APPROVAL <i>Slw</i>	REQUEST FOR COUNCIL ACTION	MEETING DATE 01/03/17
REPORTS & RECOMMENDATIONS	RESOLUTION CONDITIONALLY APPROVING A 3 LOT CERTIFIED SURVEY MAP, BEING THAT PART OF THE SOUTHEAST 1/4 OF THE SOUTHWEST 1/4 OF SECTION 13, TOWNSHIP 5 NORTH, RANGE 21 EAST, IN THE CITY OF FRANKLIN, MILWAUKEE COUNTY, WISCONSIN (RYAN S. KONICEK, OPERATOR OF BRIDGESTONE CAPITAL LLC, APPLICANT) (8647 SOUTH 35TH STREET)	ITEM NUMBER <i>G. 5.</i>
<p>At its December 22, 2016, meeting the Plan Commission recommended approval of a resolution conditionally approving a 3 lot certified survey map, being that part of the Southeast 1/4 of the Southwest 1/4 of Section 13, Township 5 North, Range 21 East, in the City of Franklin, Milwaukee County, State of Wisconsin (Ryan Konicek, Operator of Bridgestone Capital LLC, Applicant) (8647 South 35th Street).</p> <p style="text-align: center;">COUNCIL ACTION REQUESTED</p> <p>A motion to adopt Resolution No. 2017-_____, a resolution conditionally approving a 3 lot certified survey map, being that part of the Southeast 1/4 of the Southwest 1/4 of Section 13, Township 5 North, Range 21 East, in the City of Franklin, Milwaukee County, State of Wisconsin (Ryan Konicek

CERTIFIED SURVEY MAP NO. _____

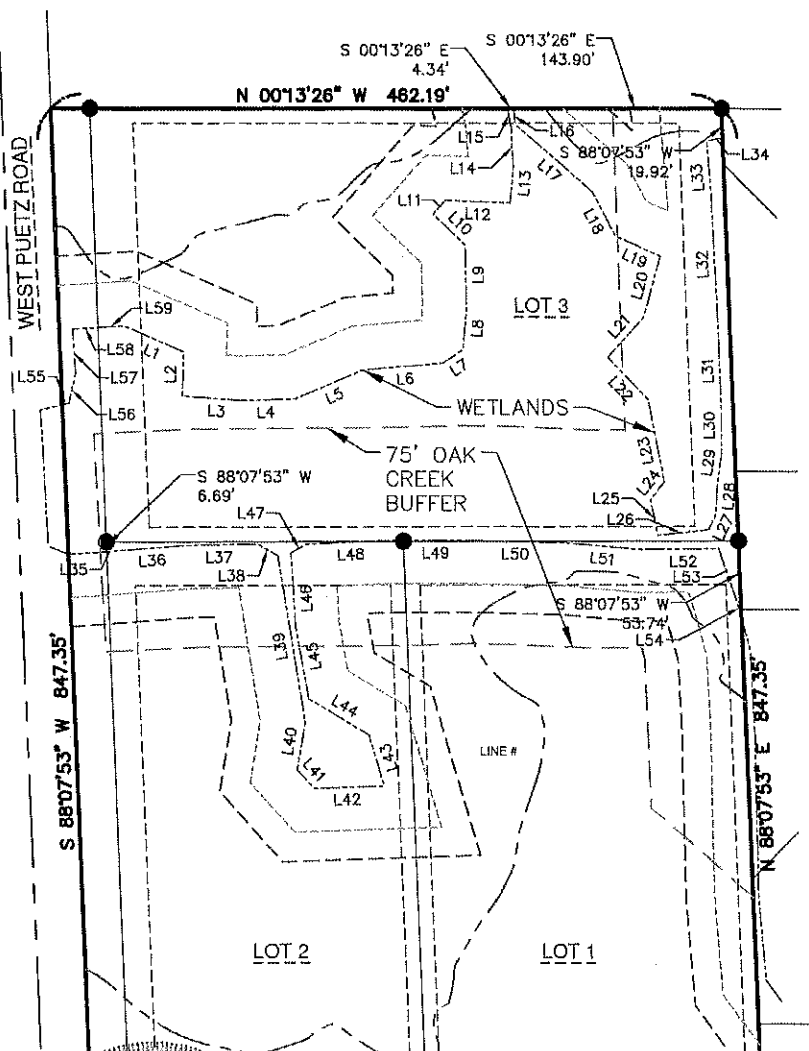
- The "Building Setback" note at the bottom of Sheet 1 shall be revised to include the 19-foot Corner Side Yard Setback.
- The note on Sheet 1 indicating the zoning of the property shall be revised to state both R-6 Residence District and C-1 Conservancy District.
- The Conservation Easement shall be shown more clearly on both Sheet 1 and Sheet 2 of the Certified Survey Map.
- The note indicating that wetlands were delineated by GRAEF on October 20, 2014 shall be revised to also include the name of the individual that performed the delineation.

- The 12-foot wide roadway dedication adjacent to S. 35th Street shall be labeled similar to the labeling provided for the 27-foot dedication along W. Puetz Road.
- The note on Sheet 4 under Common Council approval shall be revised to add "dedication" between "and" and "approved."
- The applicant shall submit a written Conservation Easement document for Common Council review and approval and recording with the Milwaukee County Register of Deeds.

11. The “Building Setback” note at the bottom of Sheet 1 shall be revised to include the 19-foot Corner Side Yard Setback.
12. The note on Sheet 1 indicating the zoning of the property shall be revised to state both R-6 Residence District and C-1 Conservancy District.

13. The Conservation Easement shall be shown more clearly on both Sheet 1 and Sheet 2 of the Certified Survey Map.
14. The note indicating that wetlands were delineated by GRAEF on October 20, 2014 shall be revised to also include the name of the individual that performed the delineation.

15. The 12-foot wide roadway dedication adjacent to S. 35th Street shall be labeled similar to the labeling provided for the 27-foot dedication along W. Puetz Road.

COMMON COUNCIL APPROVAL

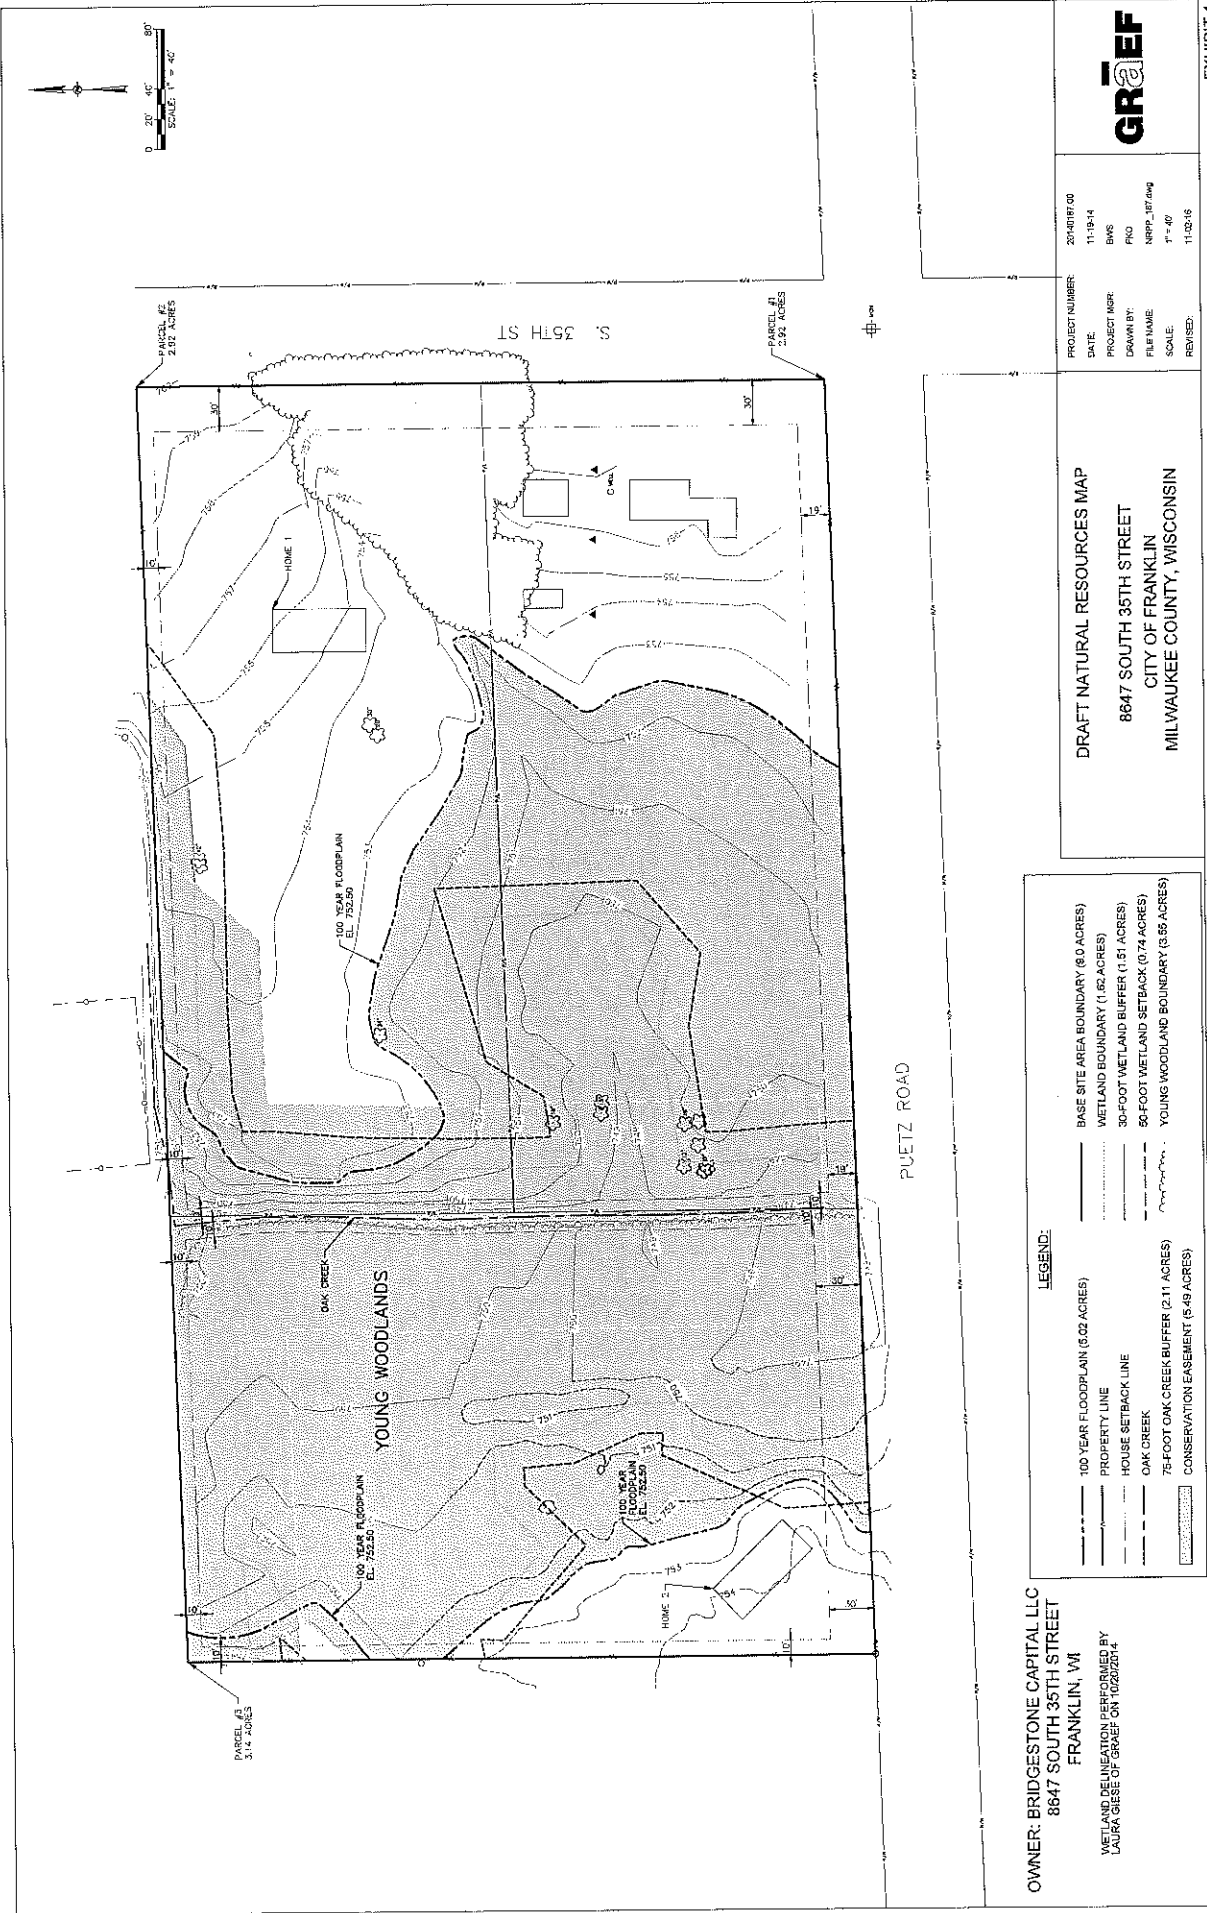
16. The note on Sheet 4 under Common Council approval shall be revised to add “dedication” between “and” and “approved.”
17. The applicant shall submit a written Conservation Easement document for Common Council review and approval and recording with the Milwaukee County Register of Deeds.
